ISSUE	DATE	REVISION
A	16/11/22	DA Submission
B	06/03/23	RFI
C	27/09/23	LEC
D	08/11/23	LEC
E	21/11/23	LEC
F	29/01/24	Amended Issue for LEC

PROJECT
Terrace Houses

ADDRESS
2-6 Martin St, Roselands NSW 2196 Australia

DRAWING
GFA and Solar Diagrams

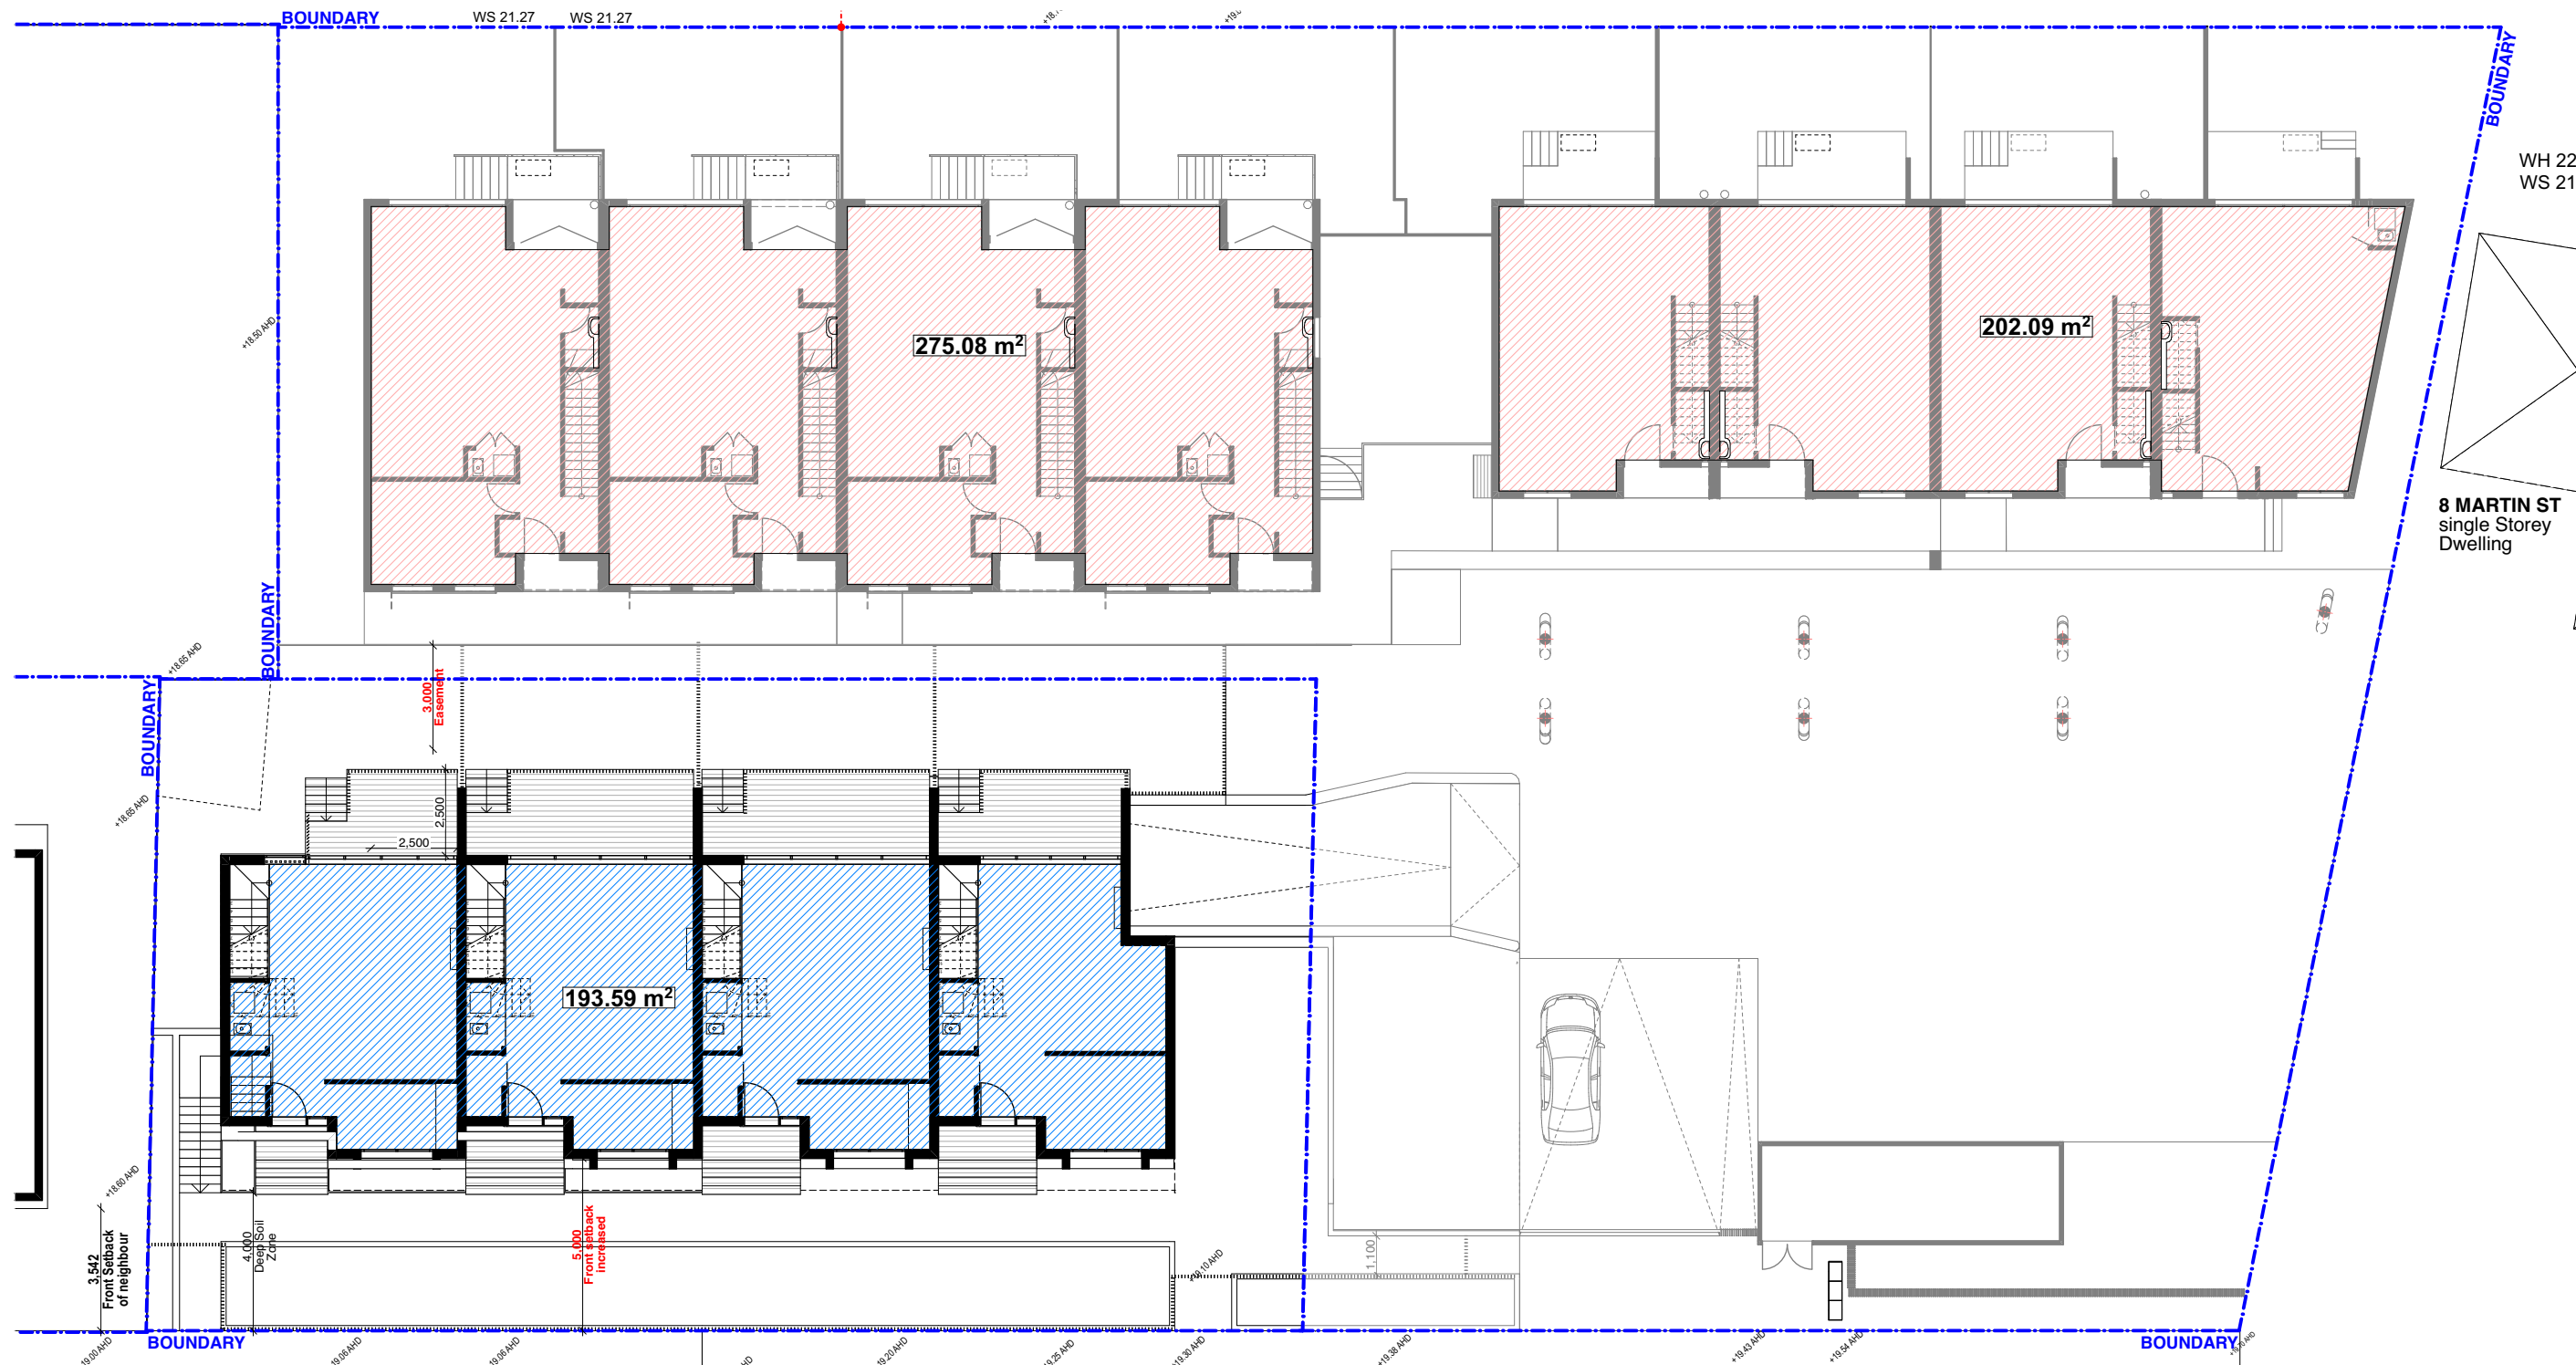
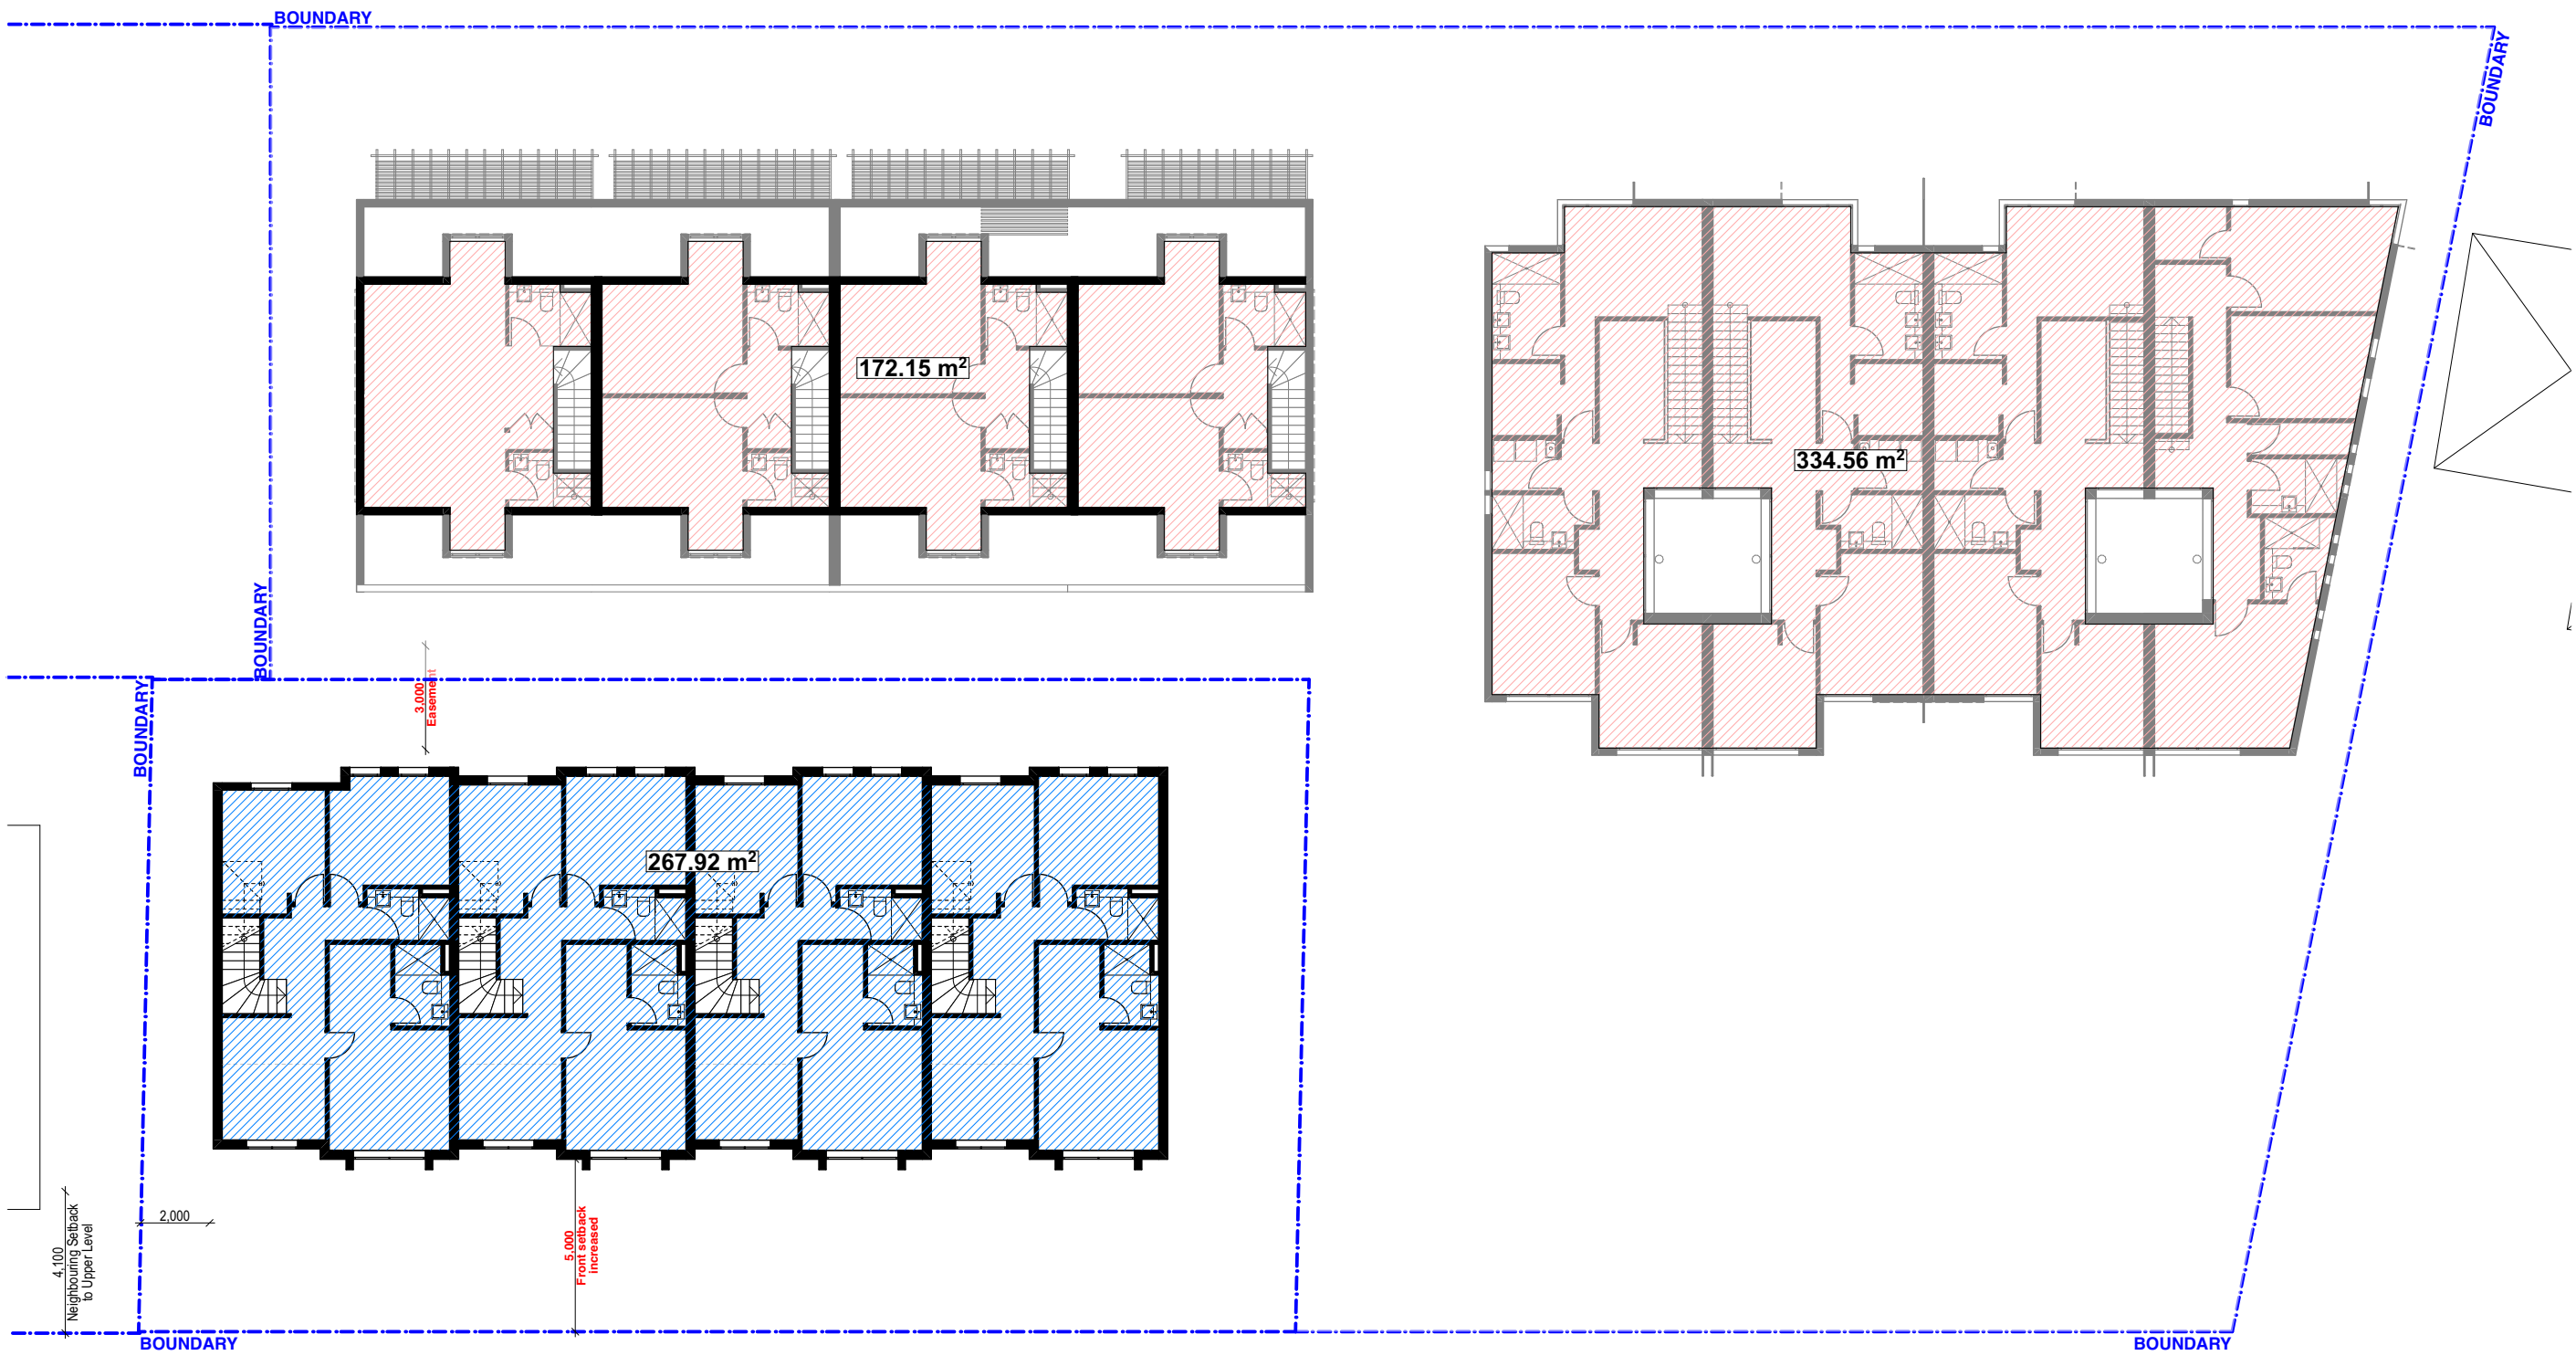
1. Calculations amended accordingly.
